Groundwater & Wastewater Services
Septic Project File & Data Review Worksheet

SUBJECT: Revised septic system design on Lot 33 in Irongate Subdivision, Brief Road, Mecklenburg Co., NC.

GWS Septic System Design Review

Irongate Subdivision Design Review

REVISED

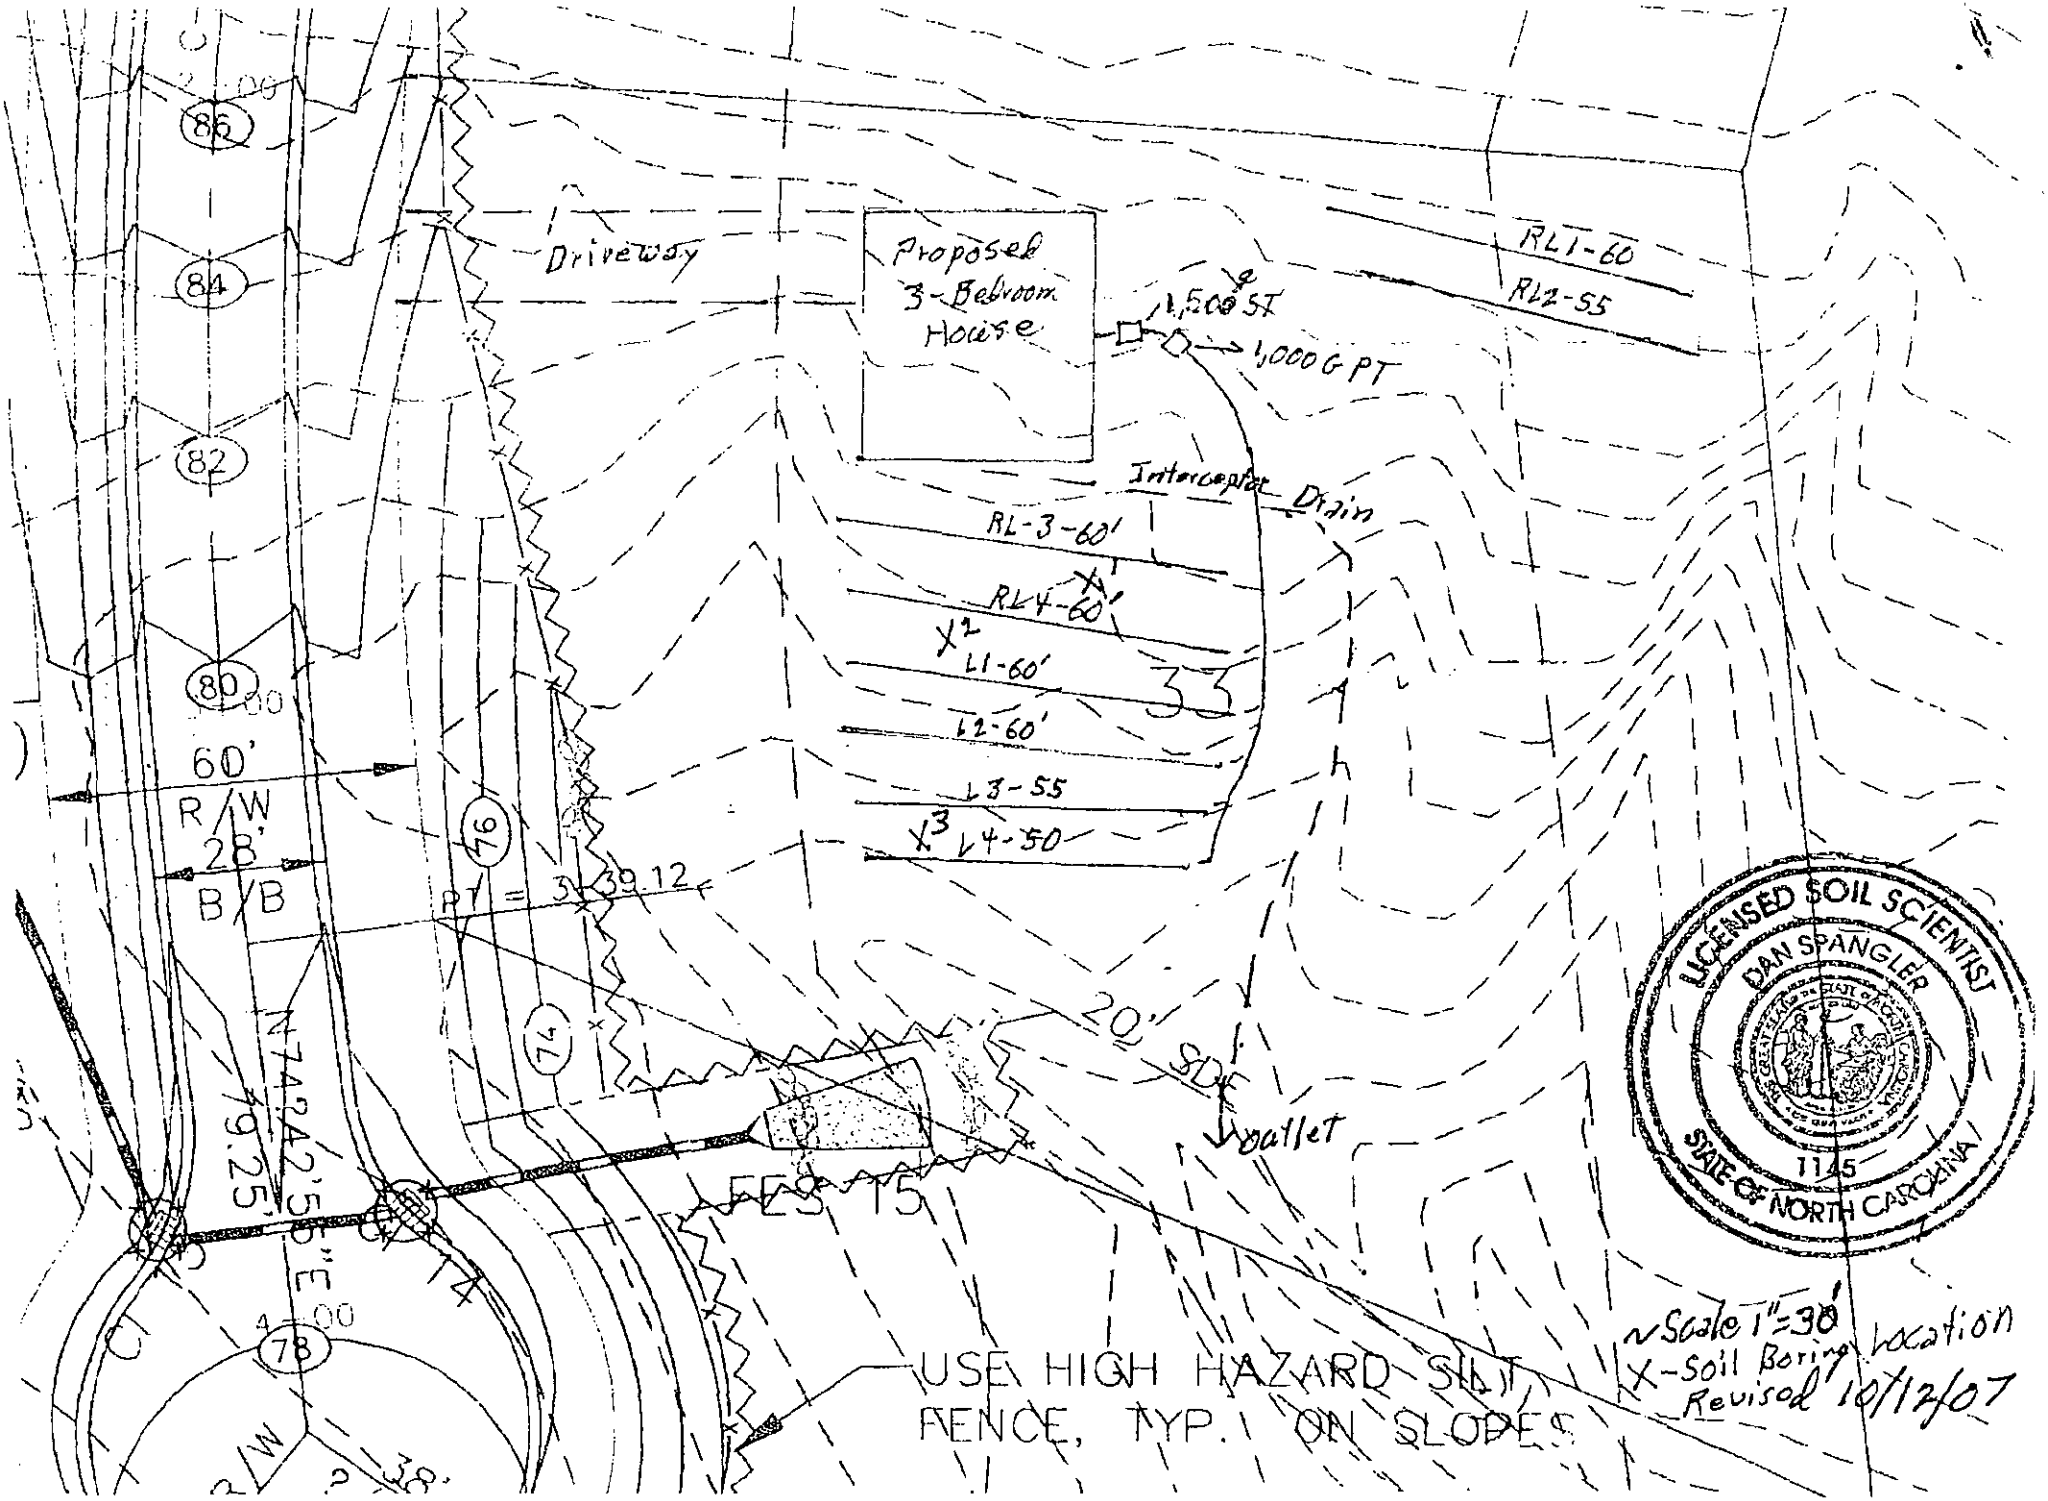
Diversion and Interceptor Drain The System would benefit from an interceptor drain four to five feet deep and outlet in the open drainage ditch in the lower part of the lot. This Interceptor drain shall be one foot wide with agricultural drainage pipe placed in the bottom and crushed stone around the pipe and up to one foot below ground. Fabric material should be placed on top of the stone. Also gutters should be installed on the house and outlet in the interceptor drain. (See attached lot map.)

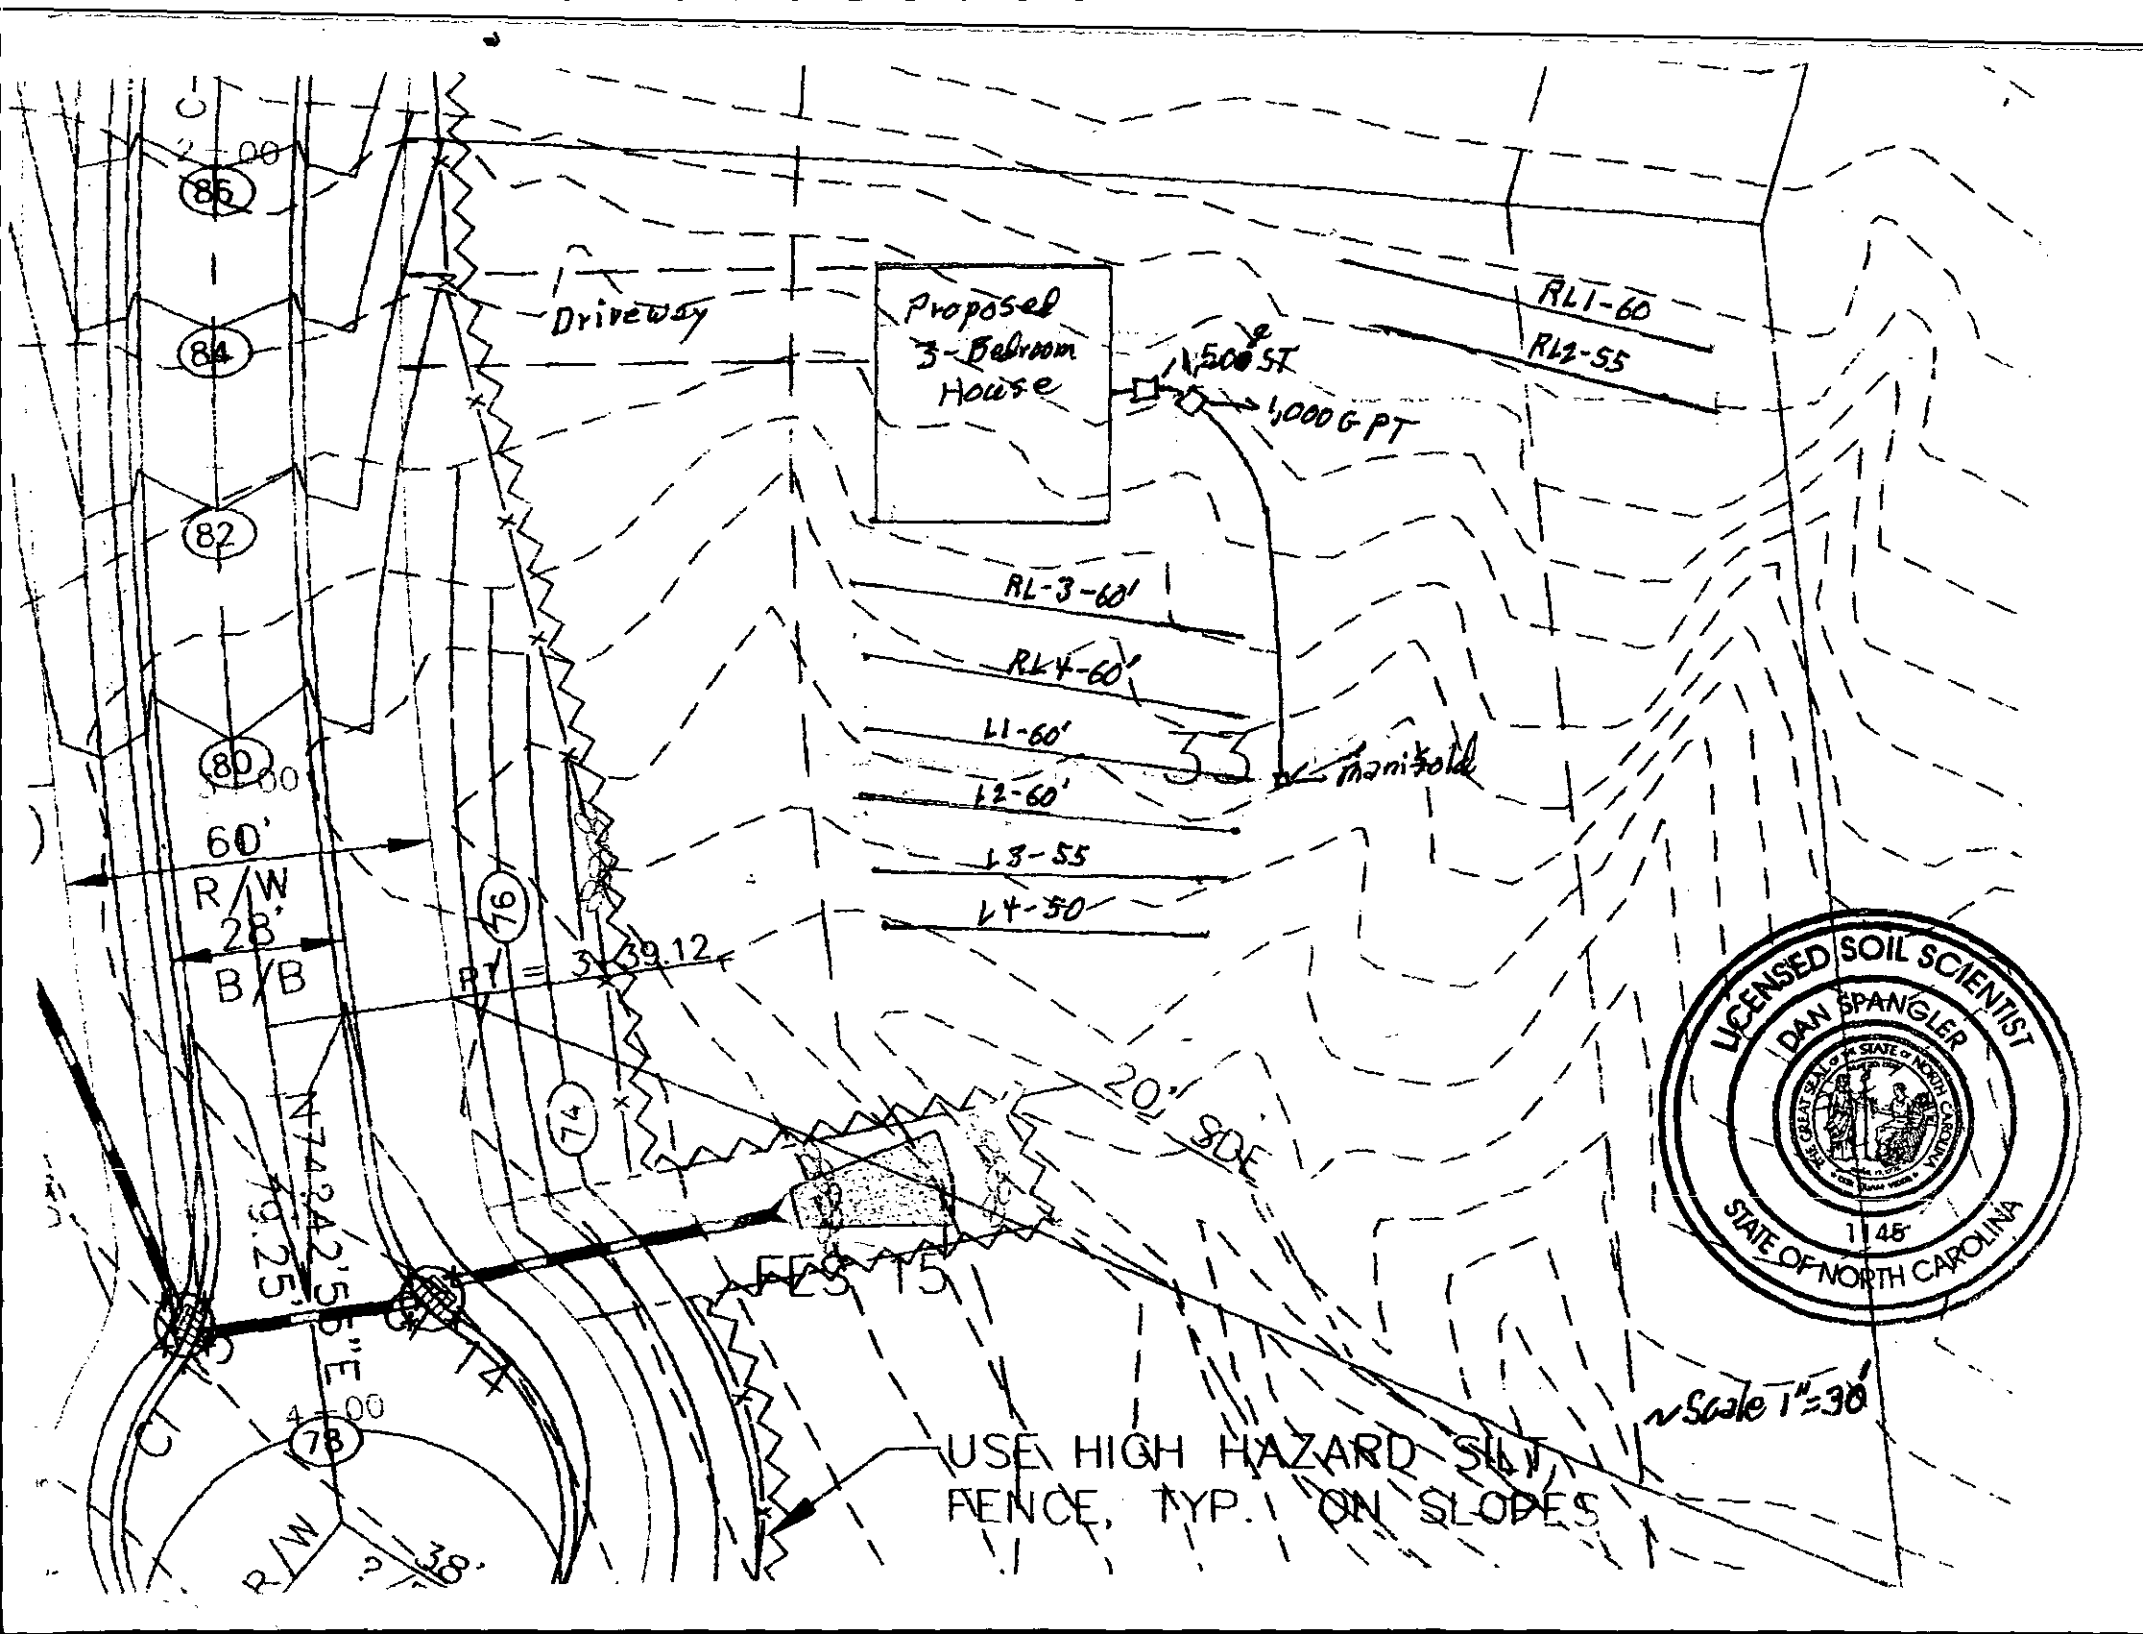
+ NEED SOIL BORINGS IN PROPOSED DRAINFIELD AREAS. MAP INDICATES COMPLEX SLOPES. TCT 9-12-07

1. Please provide a map showing your soil boring locations for the profiles included in the proposal. Proposed system is in area with complex & eroded slopes. Bill did not perform soil borings in this area.
2. Provide correct calculations for PPBPS system type. Recalculate system dose volume and system flow rate (see worksheet provided).
3. Discard manifold design sheet. This manifold type may not be used with a PPBPS system.
